## Access Compliance Report Public Rights-of-Way (Curb Ramps)

Intersection ID: 18177 Main Street: OLD\_PINEVILLE\_RD Cross Street: SCHOLTZ\_RD Location: SW

ADA ID: BD70ABEE9346 Ramp Type: PerpDiag Initial Pass/Fail: Fail Overall Compliance: No Severity Score: 33.75

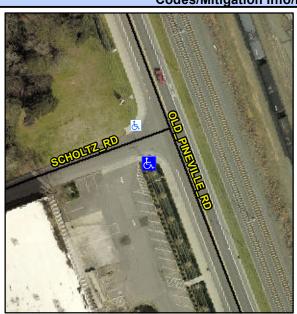
R304.5.1, R304.5.3

rieid Measurements/Component Compilance					
Compliance Description		Data	Comp	oliance Description	Data
N/A	Ramp Length (in)	74.0	Yes	Ramp Slope (%)	5.1
No	Ramp Width (in)	46.0	No	Ramp XSlope (%)	13.8
N/A	Flare Type LT	N/A	N/A	Flare Type RT	N/A
N/A	Flare Slope LT (%)	N/A	N/A	Flare Slope RT (%)	N/A
N/A	Flare Traversable LT?	N/A	N/A	Flare Traversable RT?	N/A
N/A	Landing Length (in)	N/A	N/A	DWS Provided?	N/A
N/A	Landing Width (in)	N/A	N/A	DWS Contrast?	N/A
N/A	Landing Slope (%)	N/A	N/A	DWS Length (in)	N/A
N/A	Landing X Slope (%)	N/A	N/A	DWS Full Width?	N/A
N/A	Landing Curb? (Y/N)	N/A	N/A	DWS Offset (in)	N/A
N/A	Shared Landing?	N/A			
N/A	Gutter Ponding?	N/A	N/A	Gutter Slope (%)	N/A
N/A	Gutter Lip Ht (in)	N/A	N/A	Gutter X Slope (%)	N/A
N/A	Painted X Walk1?	No	N/A	Painted X Walk2?	No
	X Walk 1 Direction	To E		X Walk 2 Direction	To N
N/A	X Walk 1 Width (in)	N/A	N/A	X Walk 2 Width (in)	N/A
	X Walk 1 Slope (%)	10.9		X Walk 2 Slope (%)	4.2

X Walk 1 X Slope (%)	2.8		X Walk 2 X Slope (%)	9.8
N/A	Ramp inside XWalk1?	N/A	N/A	Ramp inside XWalk2?	N/A
	Road Slope (%)	8.2	N/A	Clear Space?	N/A
	Road X Slope (%)	6.8	N/A	Clear Space to XWalk (in)	N/A
N/A	Any Obstructions?	N/A	N/A	Storm Grate/Utility Hazard?	N/A
	Obstruction Type			Storm Grate/Utility Type	
		N/A			N/A
			Yes	Surface Condition? (G/P)	Good

OLD PINEVILLE RD None SCHOLTZ RD StopSign Possible Solutions:

Remove & Replace Curb Ramp With Two New Directional Ramps or Equivalent.
